April 8, 2024

Subject: Review Comment Response  
Geologic Hazards Evaluation and  
Preliminary Geotechnical Investigation  
Crossroads North  
Marksheffel Road and State Highway 24  
El Paso County, Colorado  
Project No. CS18526.001-105

This letter presents our response to review comments regarding our Geologic Hazards Evaluation and Preliminary Geotechnical Investigation for Crossroads North, located in El Paso County, Colorado. The following discussion provides specific items from comments and our responses.

FIG. 2 – SURFICIAL GEOLOGIC MAP

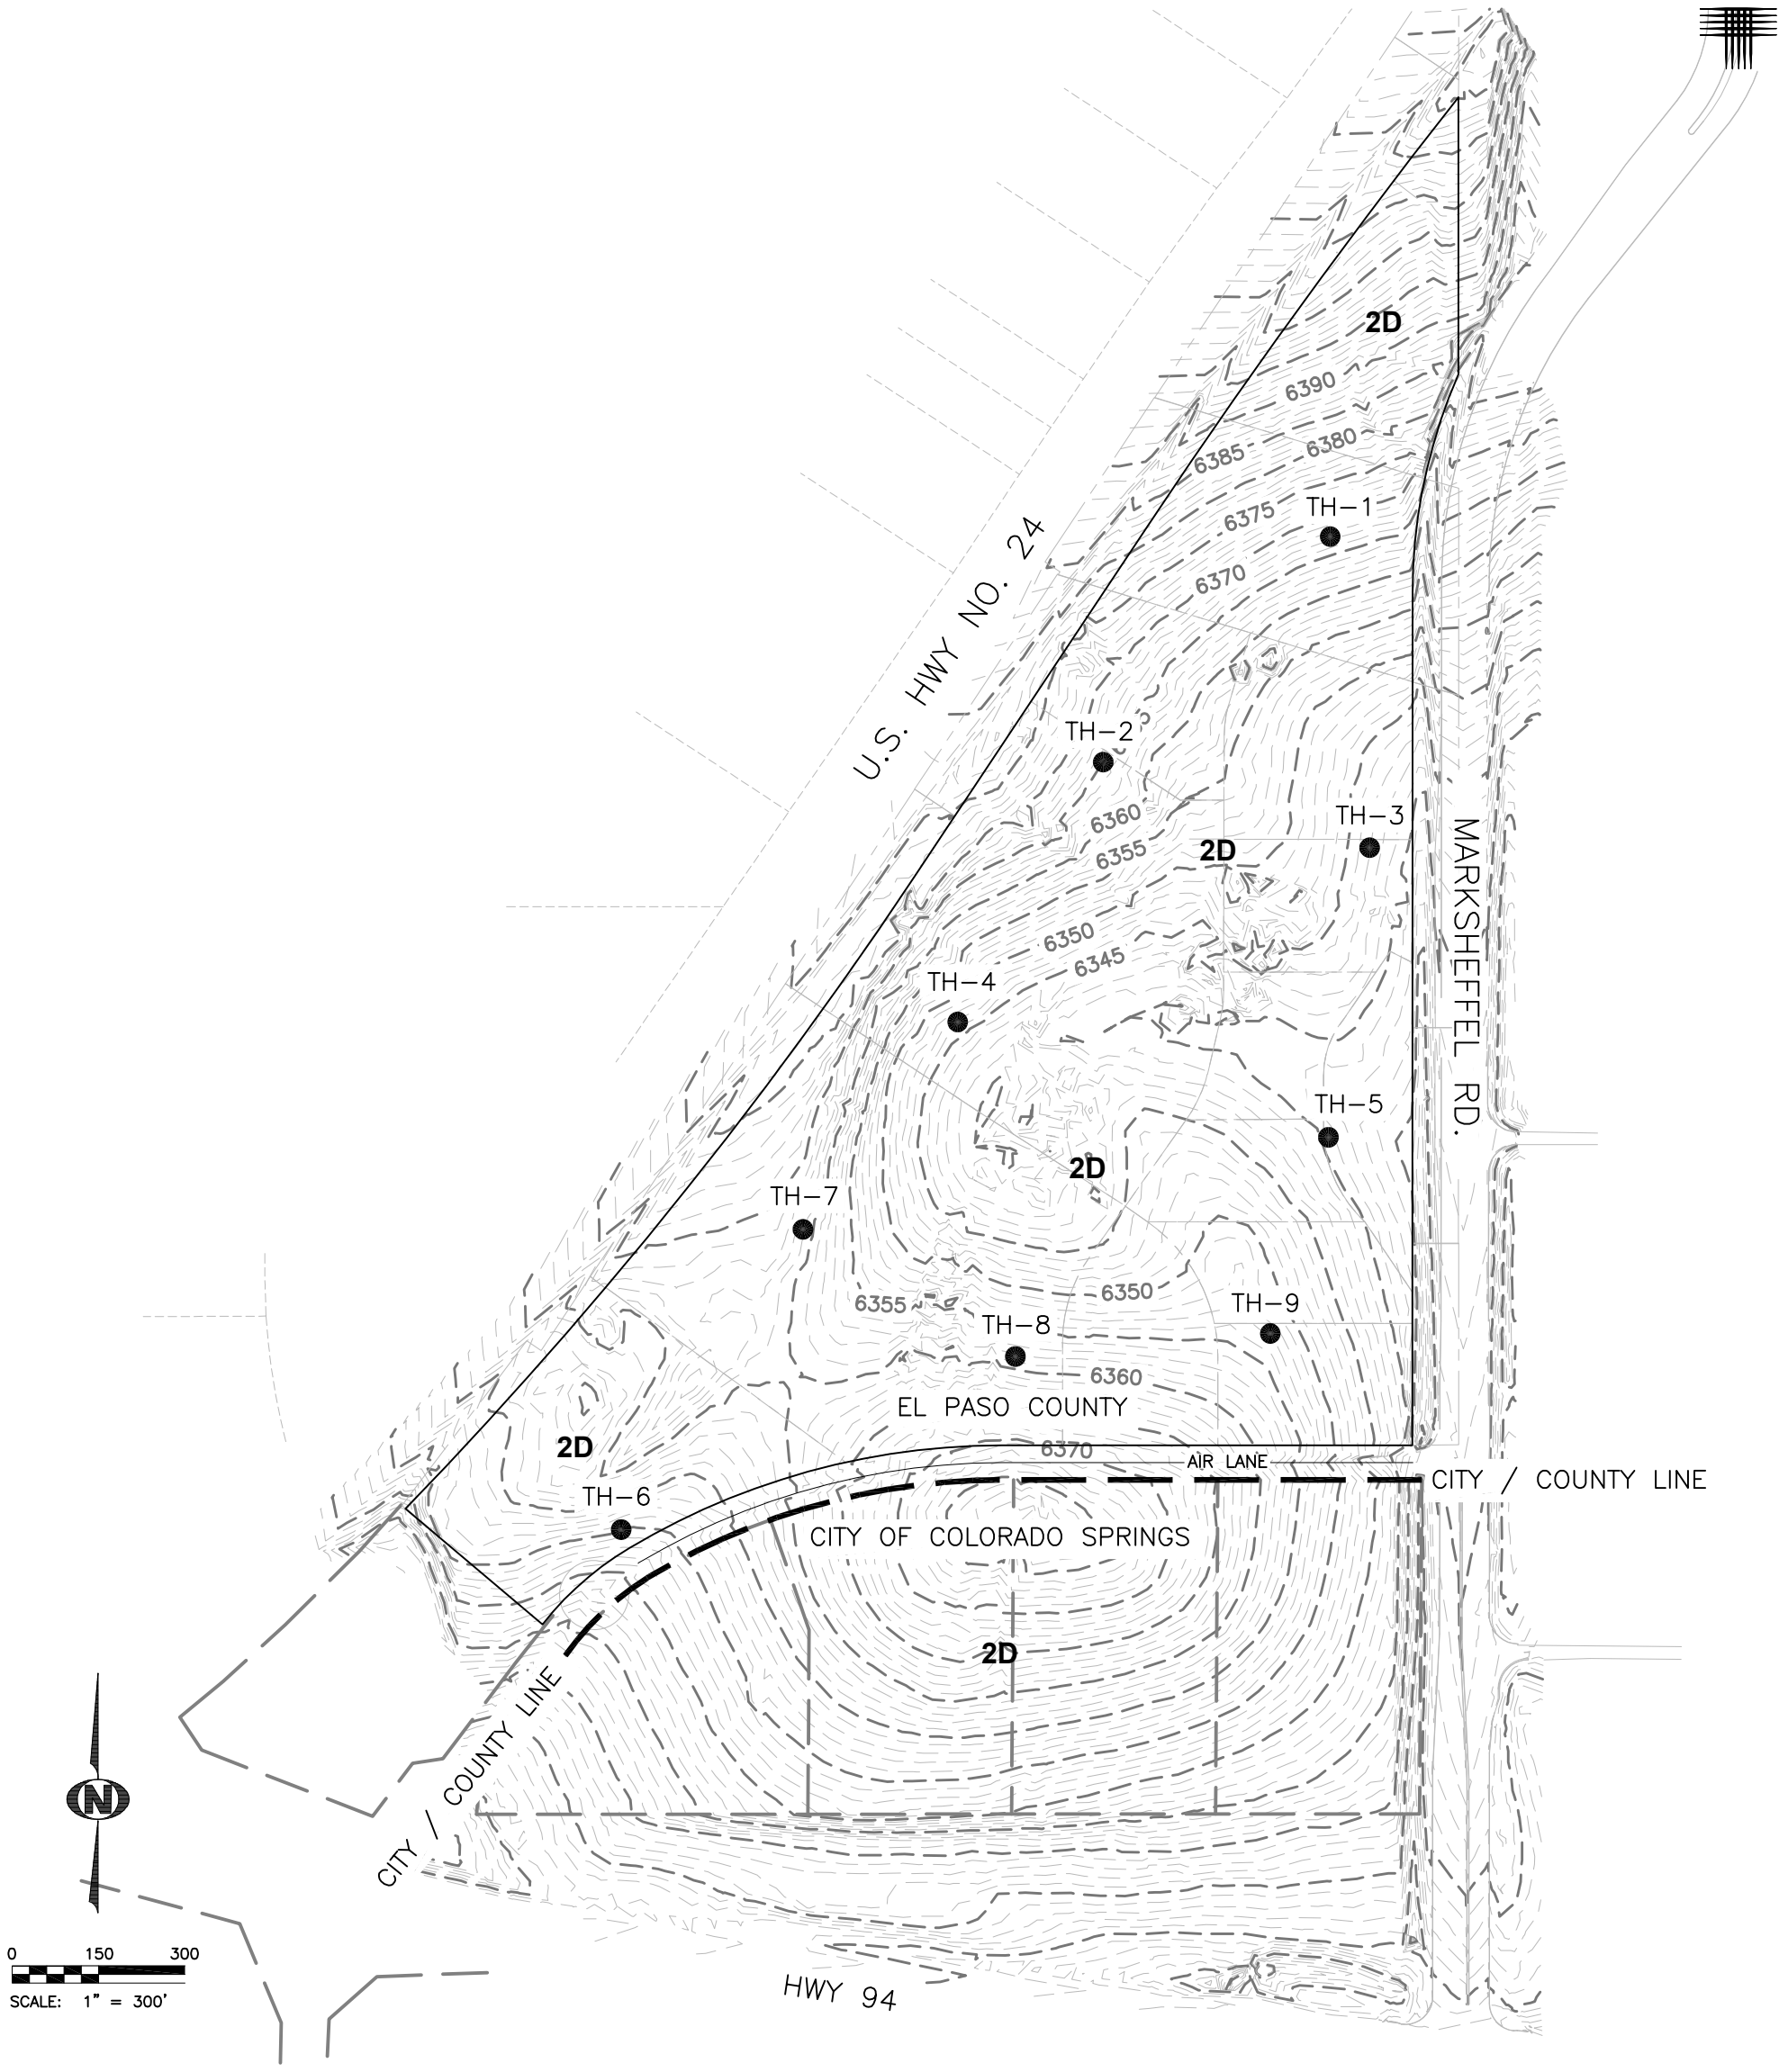
“Previous comments have not been addressed regarding soils & geology notes.”

“These geologic constraints also need to be depicted on the plan.”

“Update this note to the standard format for Soil and Geology Conditions...”

Existing fill stockpiles are mapped on Fig. 2 of the report and labeled as map unit “af”. Potentially hydro-compactive soils may be present anywhere within the development and cannot be mapped with any reasonable degree of accuracy. Attempting to map hydro-compactive soils within the site would falsely suggest the potential presence in some areas and not within other areas.

- Potentially hydro-compactive soils: may be present anywhere within the entire development. Site-specific, design-level geotechnical investigations performed for each planned structure should address the behavior of the on-site sands when wetted.
- Existing fill stockpiles: various locations shown on report Fig. 2 – Surficial Geologic Map, and labeled as map unit “af”.
